**KTA-4**

**KLIPPER GUN**

Bulletin No.

**11**

## PARTS ELIMINATED

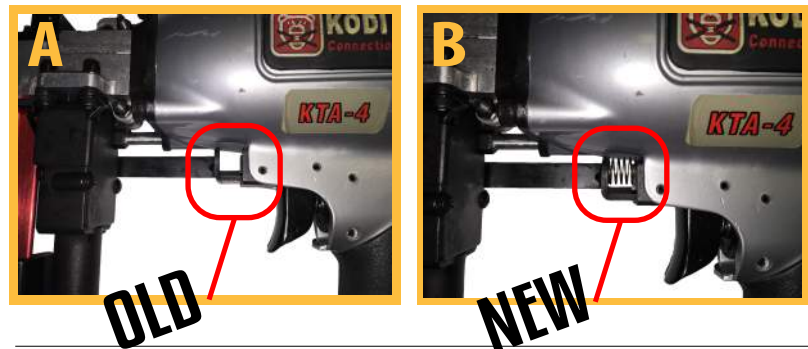
We have streamlined our Klipper Gun by redesigning one side of the Nozzle Assembly. Parts have been eliminated and the Safety Actuator Spring has been moved.

The *new* Nozzle eliminates the need for the following parts:

Included with this Service Bulletin is an updated parts breakdown and one (1) Safety Spring [PN: 70-10127]. Here is the Field Fix:

1. Install the new Nozzle [PN: 70-34421] as you would the old Nozzle [PN: 70-24421], note that you will no longer need the parts listed in the PARTS ELIMINATED box above.
2. Place the included Safety Spring [PN: 70-10127] between the flat side of the Safety Unit [PN: 70-14408] and the Safety Guide [PN: 70-10407]. [See Figures A & B]
